UNITED STATES PATENT AND TRADEMARK OFFICE

APPLICATION NO.	FILING DATE	FIRST NAMED INVENTOR	ATTORNEY DOCKET NO.	CONFIRMATION NO.
10/552,333	10/07/2005	Soo-Sang Yoon	2017-32	1868
52706 IPLA P.A. 3580 WILSHIRE BLVD. 17TH FLOOR LOS ANGELES, CA 90010	7590 04/19/2007		EXAMINER KIM, SU C	
			ART UNIT 2823	PAPER NUMBER

Office Action Summary

DETAILED ACTION

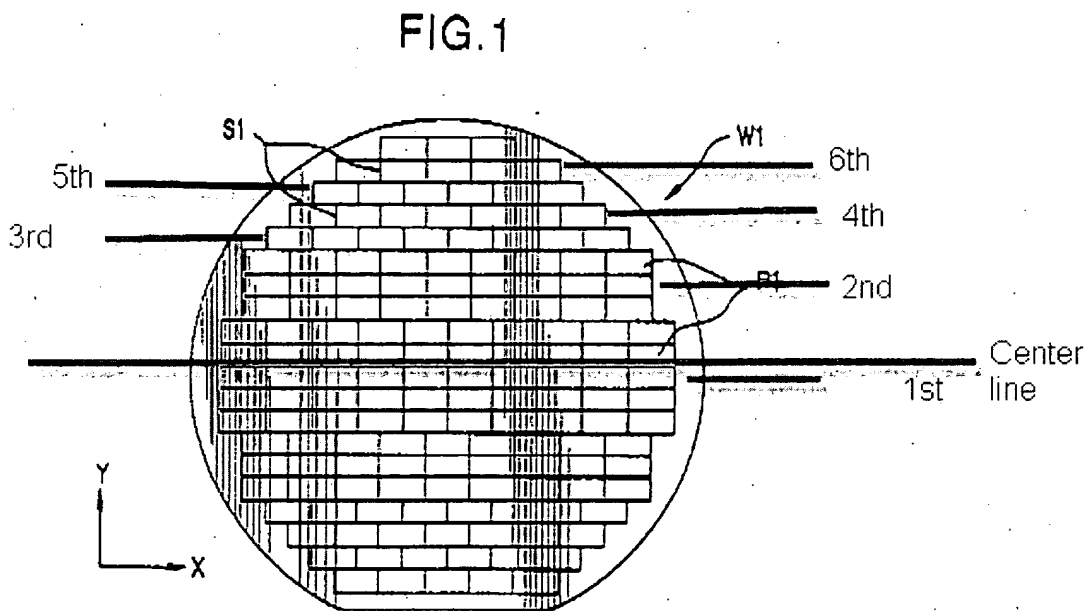
Regarding claim 1, Arai discloses a wafer, wherein a plurality of strips (Fig. 1) having a die arrangement structure in which dies are degned to have an equal width P1

(Fig. 1) are alternately arranged from the center (Fig. 1, note: some of strips are arranged alternately from the center).

Regarding claim 2, as applied to claim 1, Arai discloses first strips (see Fig. 1 below) positioned closest to the center of the wafer adjoin each other to be symmetric with each other, and other strips arranged sequentially on the outside of the first strips are alternately staggered.

first strips which have a die arrangement structure in which their dies are designed to have an equal width (Fig. 1 above, note: the 1st strips);

second strips which adjoin the first strips to be symmetric with each other, are arranged in at least one row such that their dies are designed to have an equal width, and are configured in such a manner that their dies are staggered with the respective dies of the first strips (Fig. 1 above, note: the 2nd strips);

third strips that adjoin the second strips to be symmetric with each other, are arranged in at least one row such that their dies are designed to have an equal width, and are configured in such a manner that their dies are aligned with those of the first strips but staggered with those of the second strips (Fig. 1 above, note: the 3rd strips);

fourth strips that adjoin the third strips to be symmetric with each other, are arranged in at least one row such that their dies are designed to have an equal width, and are configured in such a manner that their dies are aligned with those of the second strips but staggered with those of the first and third strips (Fig. 1 above, note: the 4th strips);

fifth strips that adjoin the fourth strips to be symmetric with each other, are arranged in at least one row such that their dies are designed to have an equal width, and are configured in such a manner that their dies are aligned with those of the first and third strips but staggered with those of the second and fourth strips (Fig. 1 above, note: the 5th strips);

and are configured in such a manner that their dies are aligned with those of the second and fourth strips but staggered with those of the first, third and fifth strips (Fig. 1 above, note: the 6th strips).
